# VALUE ENGINEERING STUDY

Project # CSSTP-0007-00(319) PI No. 0007319

SR 347/Lanier Islands Parkway from  
Lake Lanier to McEver Rd  
Hall County, Georgia

09 May 2013

# ORIGINAL DESIGN SKETCH/DETAIL

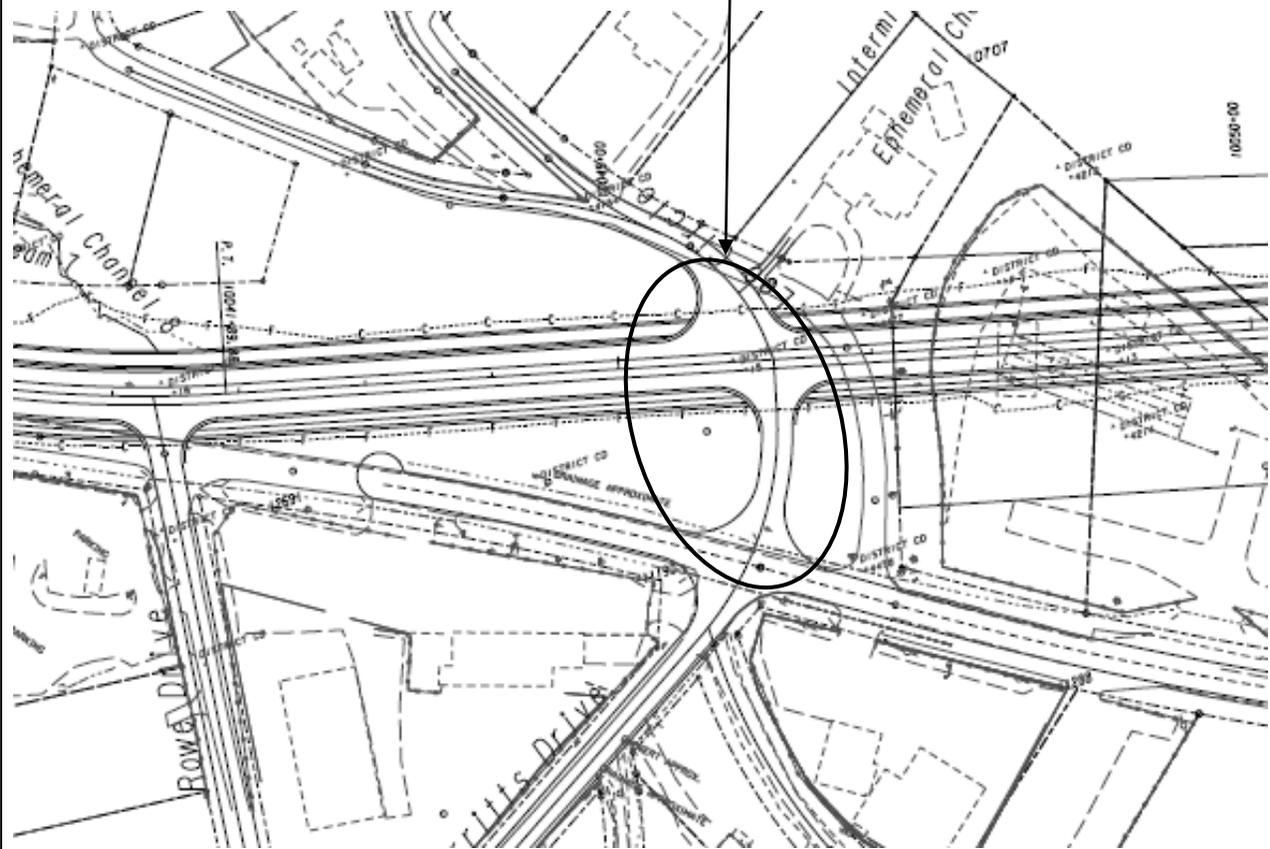
**PROPOSED CHANGE:** The proposed change is to eliminate the 130 LF extension of Lee Circle South of relocated SR 347.

Proposed Change: Eliminate Relocation of Lee Circle between Relocated and Existing SR 347

# PROPOSED CHANGE SKETCH/DETAIL

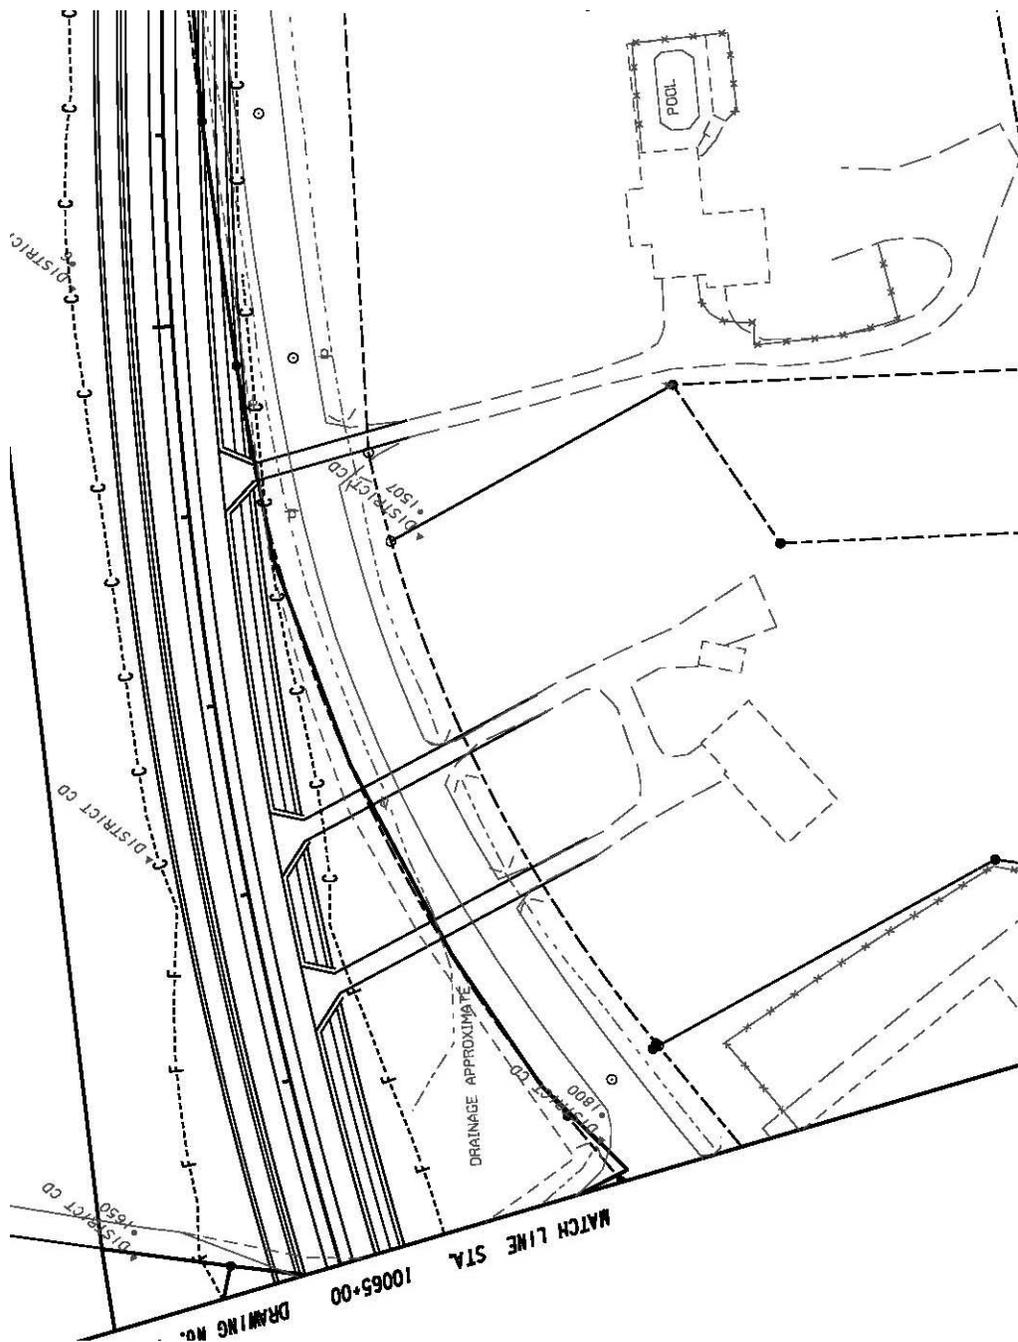
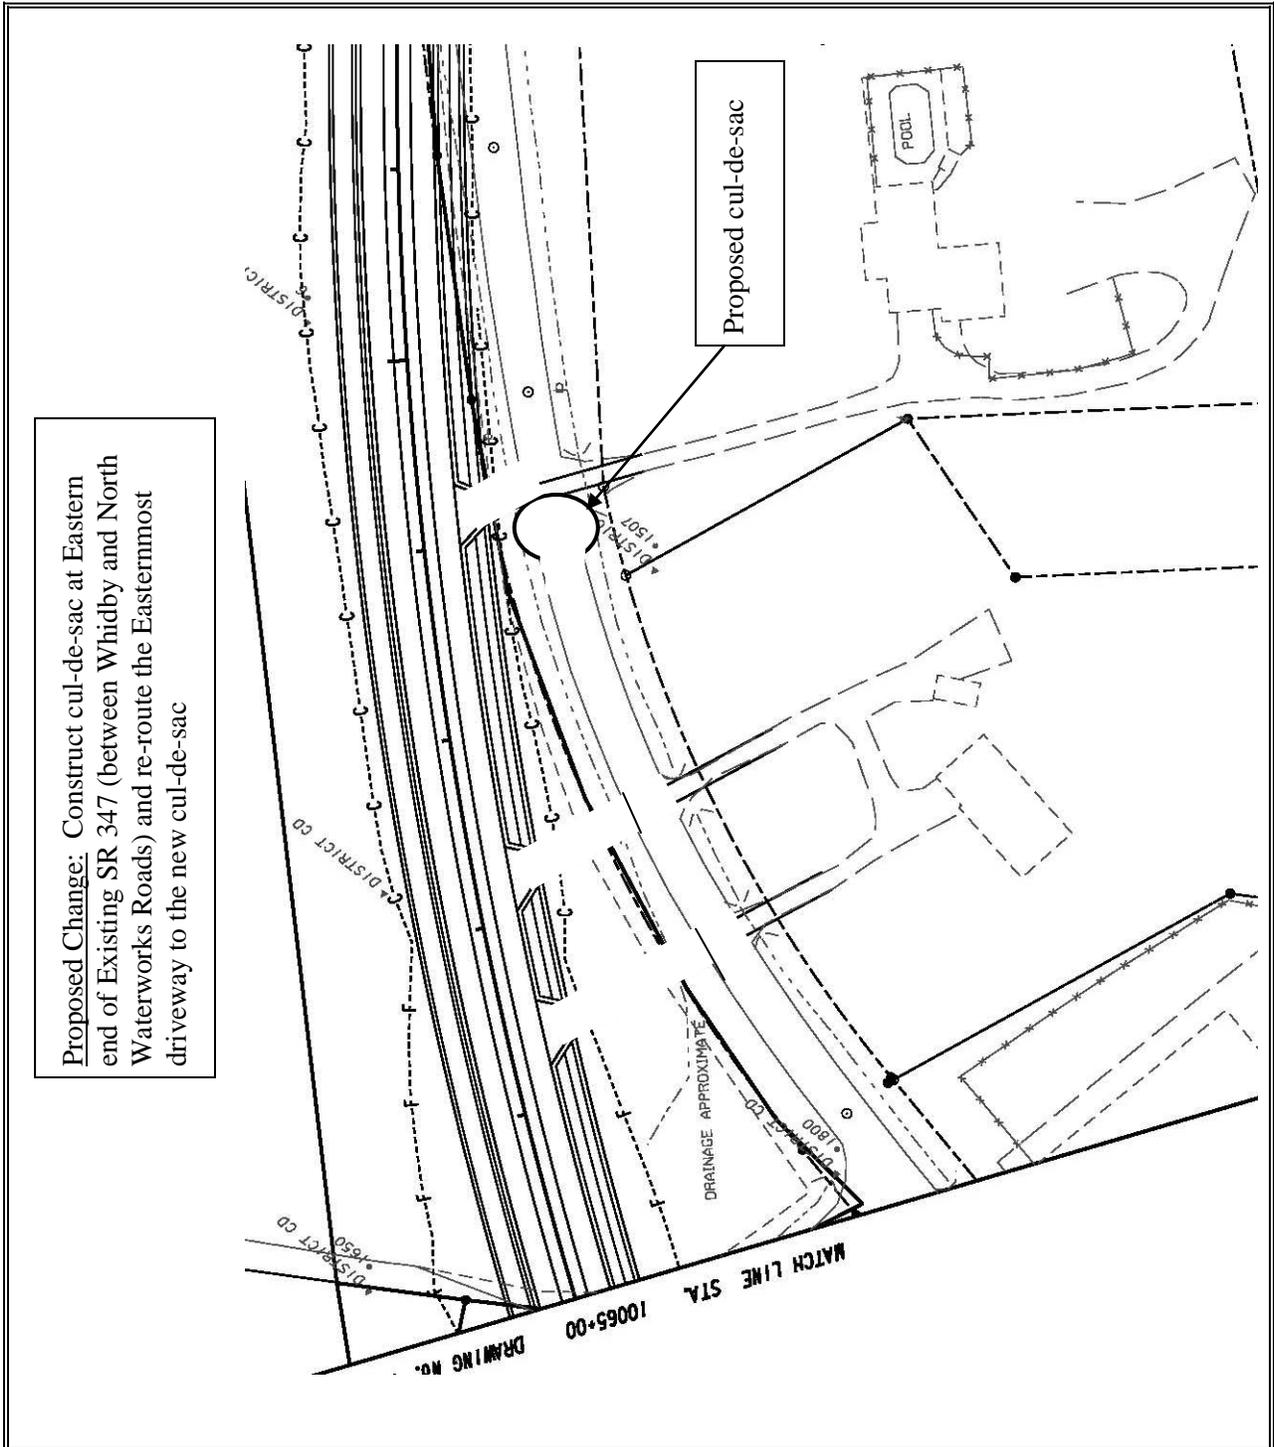
**PROPOSED CHANGE:** It is proposed to relocate the new cul-de-sac on the existing SR 347 425 feet to the East, which will then allow the 3 driveways to be connected to the existing SR 347 and eliminate the extension of the driveways.

**JUSTIFICATION:** The proposed change is similar to the approach for the Western end of existing SR 347 where the cul-de-sac is placed at the Westernmost existing driveway. This reduces construction efforts and costs.

# ORIGINAL DESIGN SKETCH/DETAIL

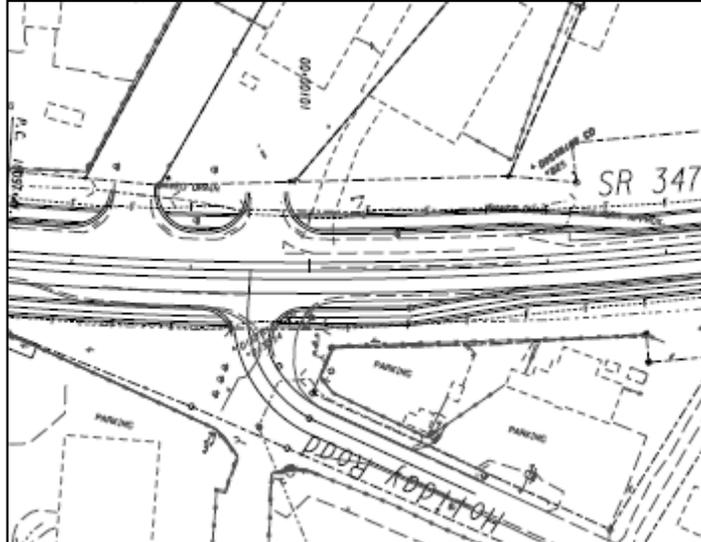
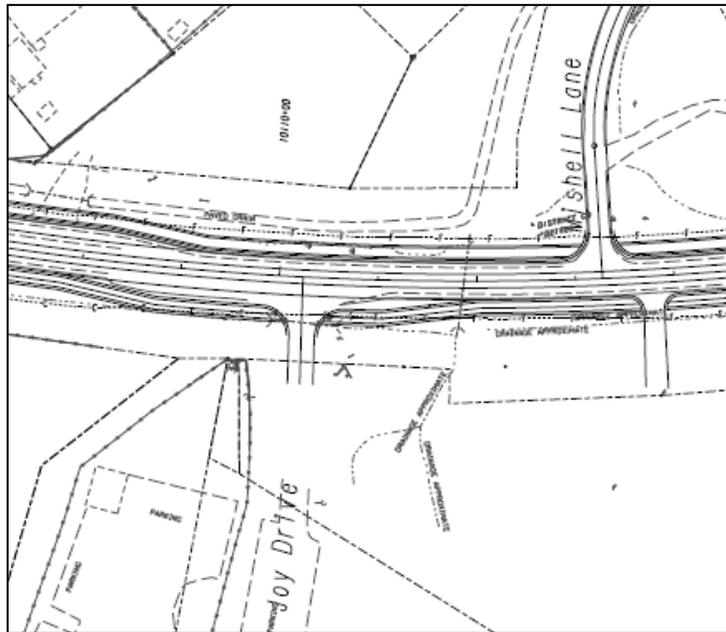
**PROPOSED CHANGE:** It is proposed to eliminate the short acceleration lanes and develop the approaches in accordance with the GDOT Regulations for Driveway and Encroachment Control.

# ORIGINAL DESIGN SKETCH/DETAIL

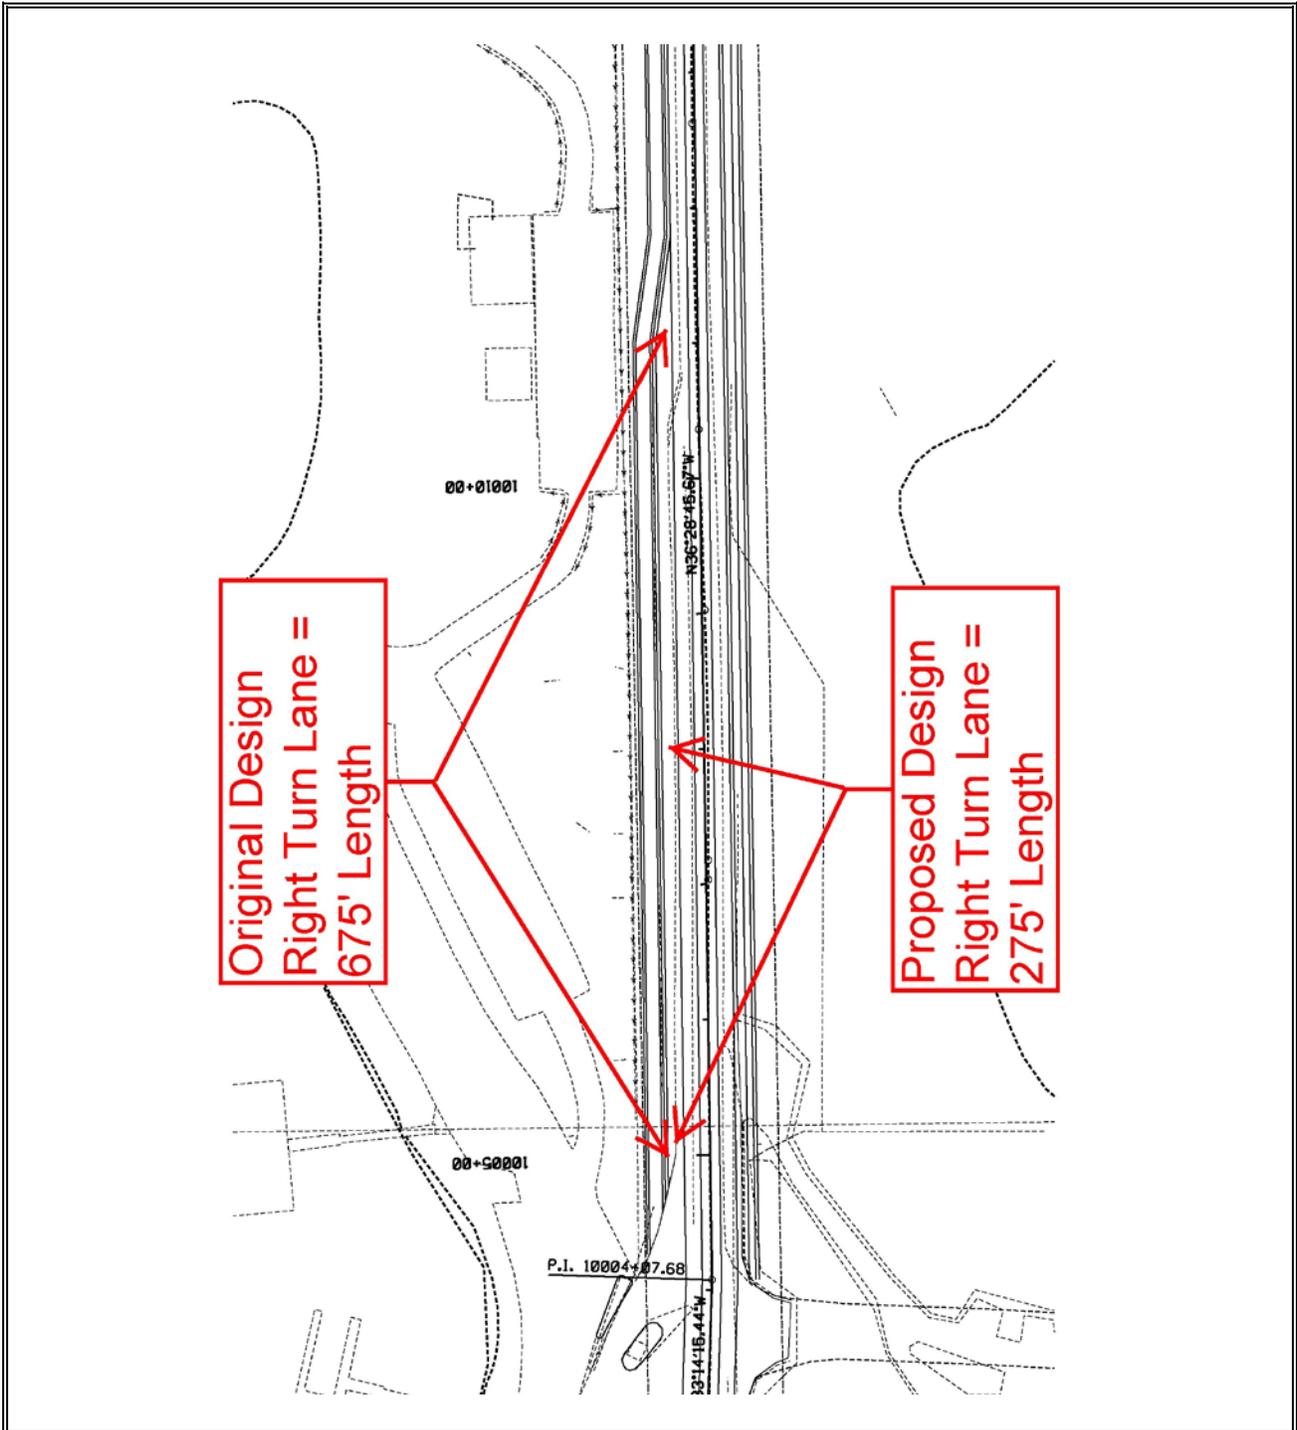
**PROPOSED CHANGE:** The proposed change is to reduce the right turn lane to 175' with a 100' taper for a total of 275', which is the minimum required right turn lane length according to GDOT criteria for a posted speed of 45 mph.

# PROPOSED CHANGE SKETCH/DETAIL

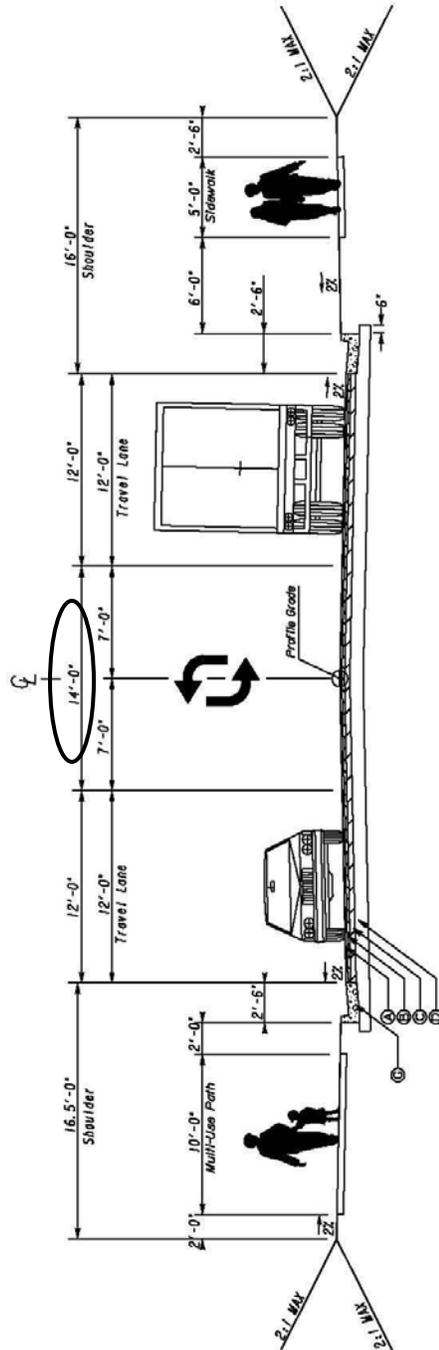
**PROPOSED CHANGE:** It is proposed to reduce the turn lane from 14' to 12', with the travel lanes remaining at 12'.

**JUSTIFICATION:** The roadway is classified as "Urban Minor Arterial" with a 45 MPH Design Speed and GDOT policy refers to AASHTO which allows continuous 2-way turn lanes to range from 10' to 16' in Section 4.3, Lane Widths, of the AASHTO Geometric Design Manual. Thus, this proposed change meets GDOT and AASHTO requirements while reducing the amount of impervious surfaces and providing a construction cost savings to the project.

Proposed Change: Reduce 4'0" turn lane to 12'0"
